Memorandum

June 17, 2008

TO: Columbia River Crossing Task Force
FROM: CRC Pedestrian and Bicycle Advisory Committee (PBAC)
SUBJECT: PBAC Recommendations for World Class Pedestrian and Bicycle Facilities

PBAC Proposed Pedestrian and Bicycle System for Replacement Bridge

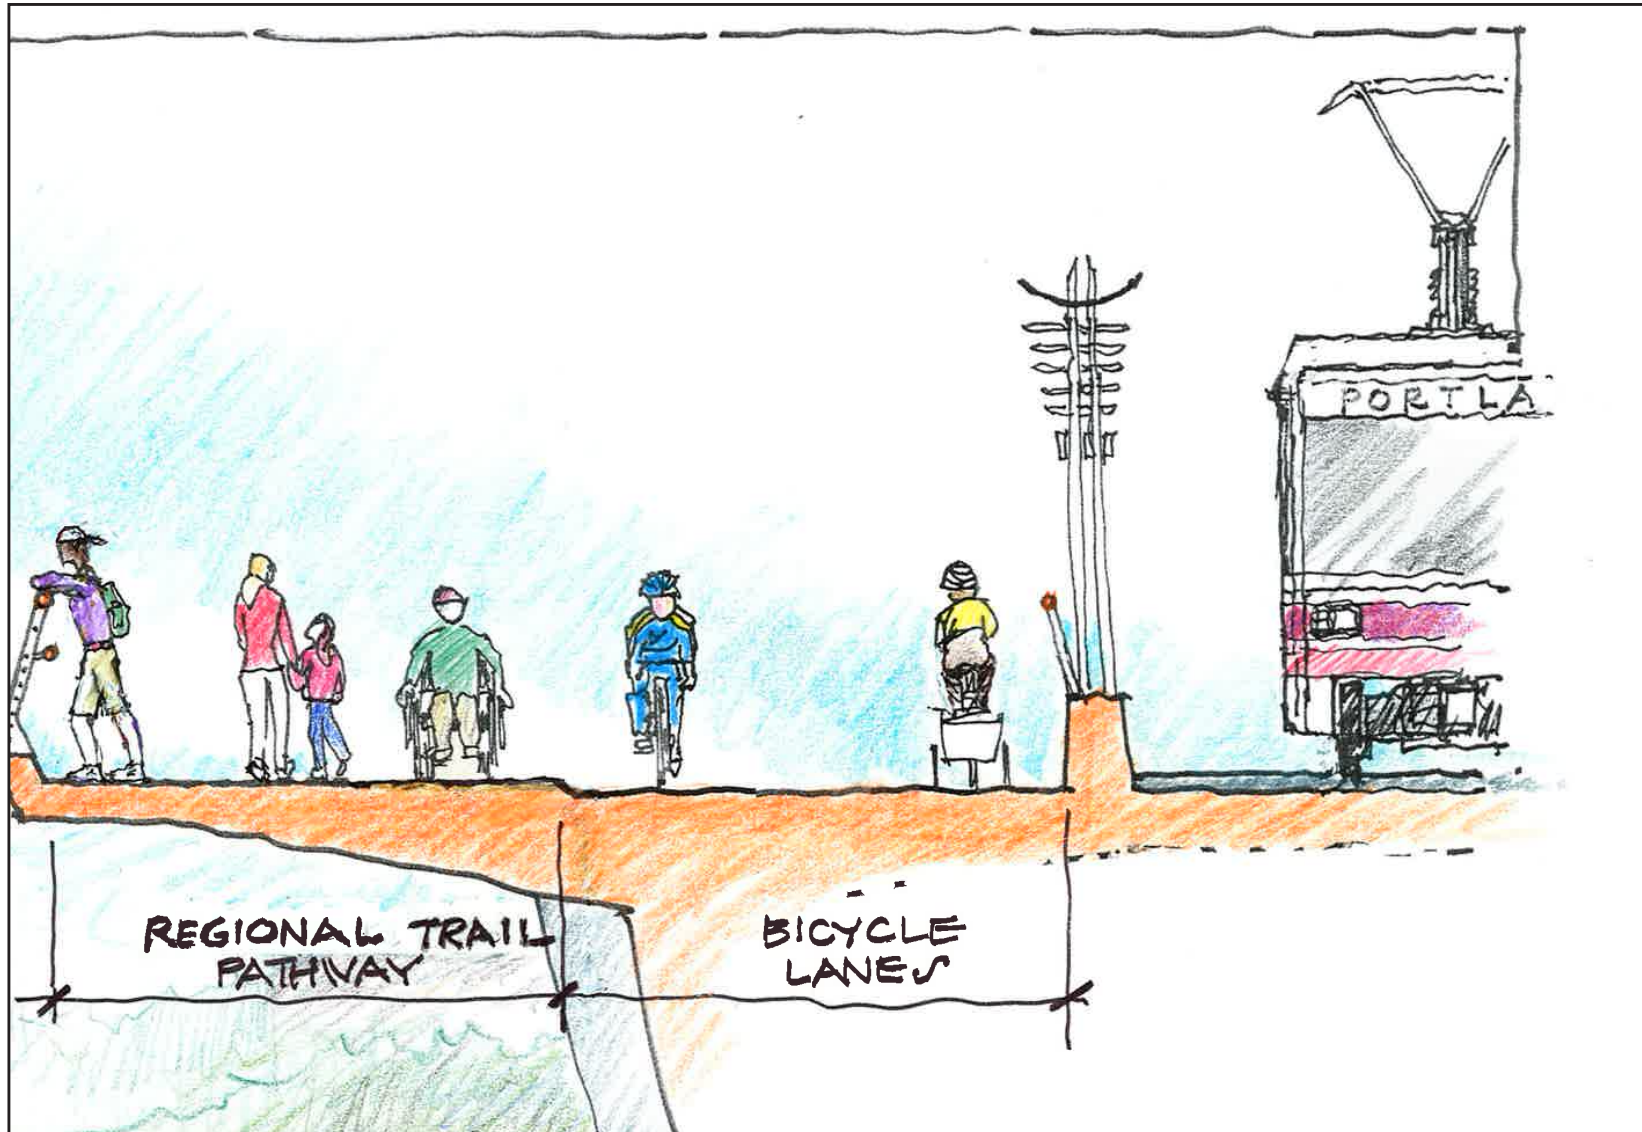
- The overall pathway on the western bridge (adjacent to the transit guideway) must provide separation between recreational users and higher speed bicycle users. To provide this separation, a 12-foot wide regional trail should be provided adjacent to, and to the west of, a pair of six-foot wide bicycle lanes (see attached rendering). These recommended widths are exclusive of potentially needed shy distances, i.e., free and clear of poles and other obstructions to enable safe pedestrian and bicycle movement (a summary of agency standards for multiuse paths, sidewalks and bike lanes is attached).

The regional trail would accommodate pedestrians, persons with disabilities, seniors, families with children, tourists, roller-skaters, and recreational bicycle riders. The adjacent bicycle lanes would be used by bicycle commuters and other faster-moving bicyclists. The regional trail would be at a slightly higher level than the bicycle lanes, but bicyclists in the bicycle lanes would be able to access the trail. Different paving treatments and/or patterns should differentiate the regional trail and the bicycle lanes.
